**RESOLUTION 2012-52, A RESOLUTION APPROVING A REVISION TO THE DEVELOPMENT PLAN FOR SIMMONS RIDGE PUD SUBDIVISION, LOCATED AT 4408 SOUTH CAROTHERS ROAD, BY THE CITY OF FRANKLIN, TENNESSEE.**

**SUBJECT:** Resolution 2012-52, A Resolution To Approve The PUD Development Plan For Simmons Ridge On ± 88.67 Acres For 408 Attached And Detached Units On The Property Located At 4408 South Carothers Road

**CLARIFICATION OF  
FRANKLIN MUNICIPAL PLANNING COMMISSION REPORT  
(Revised 11/7/2012)**

**NAME OF PROJECT:** Simmons Ridge PUD Subdivision, Development Plan, Revision 2

Exhibit A

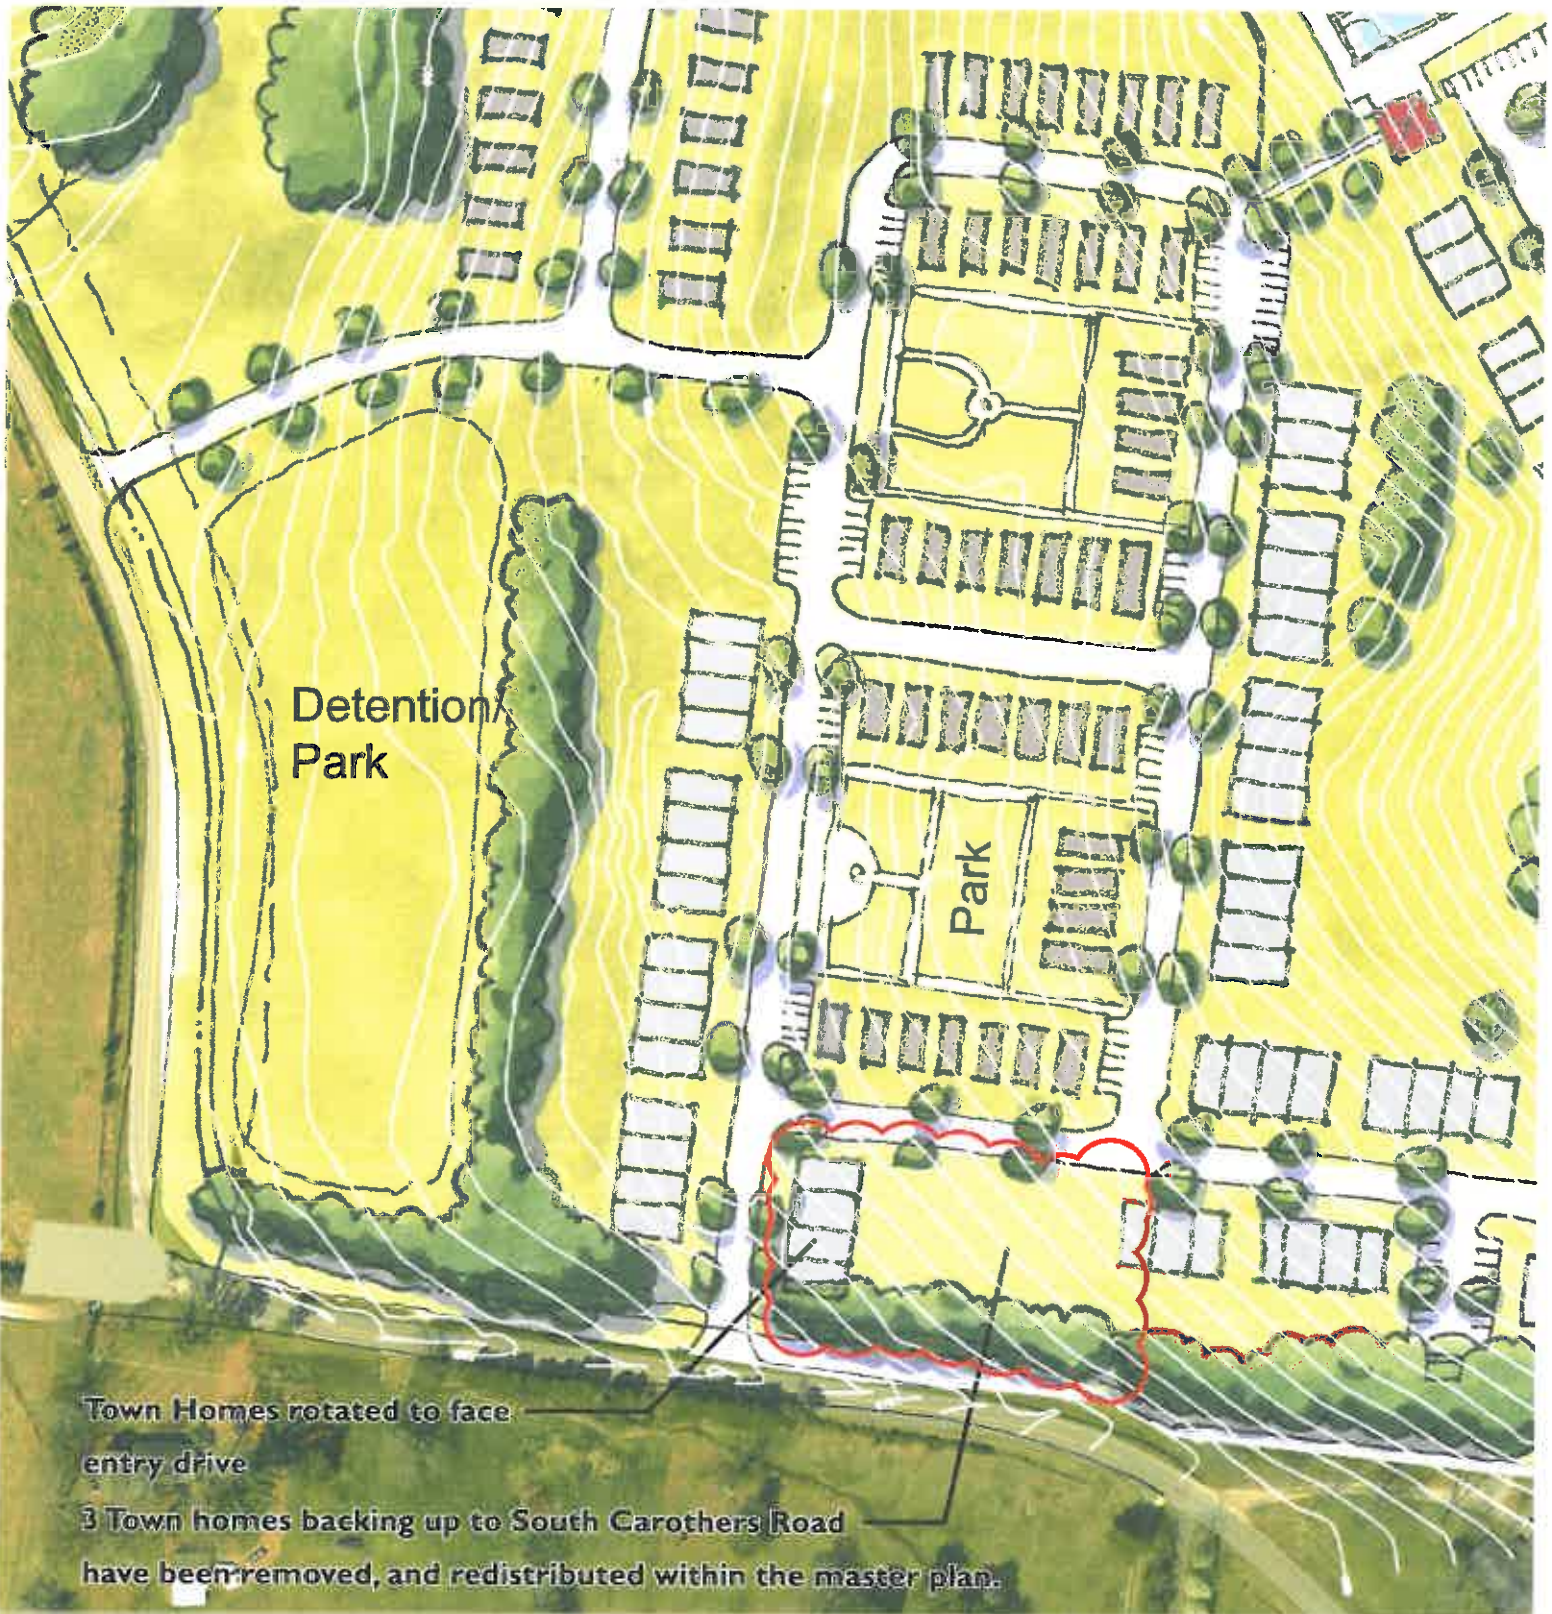
Town Homes rotated to face  
entry drive

3 Town homes backing up to South Carothers Road  
have been removed, and redistributed within the master plan.
